MACK TRUCKS, INC.
2100 MACK BOULEVARD
P.O. BOX M
ALLENTOWN, PA 18105-5000

SUBJECT: Vehicle Safety Recall - SC0293
FXL Axle Dust Shield Bolt Interference - CXN model

SC293

Subject: Interference Condition Between Front Axle Brake Dust Shield Mounting Bolt and Lower King Pin Boss — CXN Model Chassis with FXL12 or FXL14.6 Front Steer Axle and 16.5" x 5" Brakes

Figure 8 — Dust Shield Installation

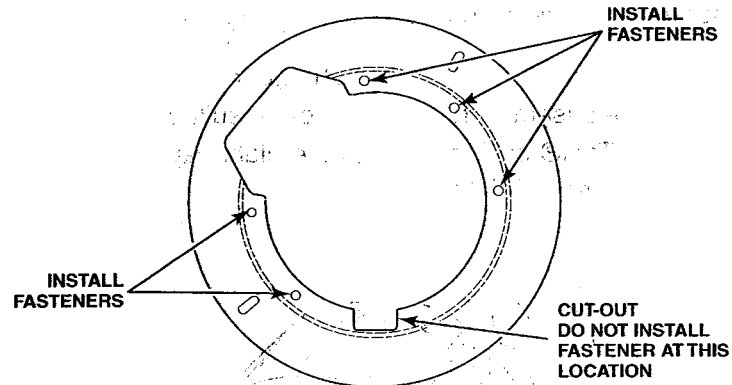
It has been determined that on certain CXN model chassis equipped with either an FXL12 or FXL14.6 front axle and ArvinMeritor 16.5" x 5" brakes, the front axle brake dust shield mounting bolt may interfere with the lower king pin boss. To eliminate the interference, revised dust shields (part Nos. 8235-3264D1486, left-hand shield, and 8235-3264C1485, right-hand shield) must be used to replace the existing shield on all affected chassis. The revised dust shields have cutouts in the area of the lower mounting bolt.

4. Remove the existing dust shield from the spider.
5. Install the replacement dust shield (part Nos. 8235-3264D1486, left-hand side, and 8235-3264C1485, right-hand side) using five fasteners. Do not install a fastener in the bottom of the dust shield where it would contact the lower king pin boss.

The replacement dust shields are designed to provide adequate clearance between the lower king pin boss and the shield.
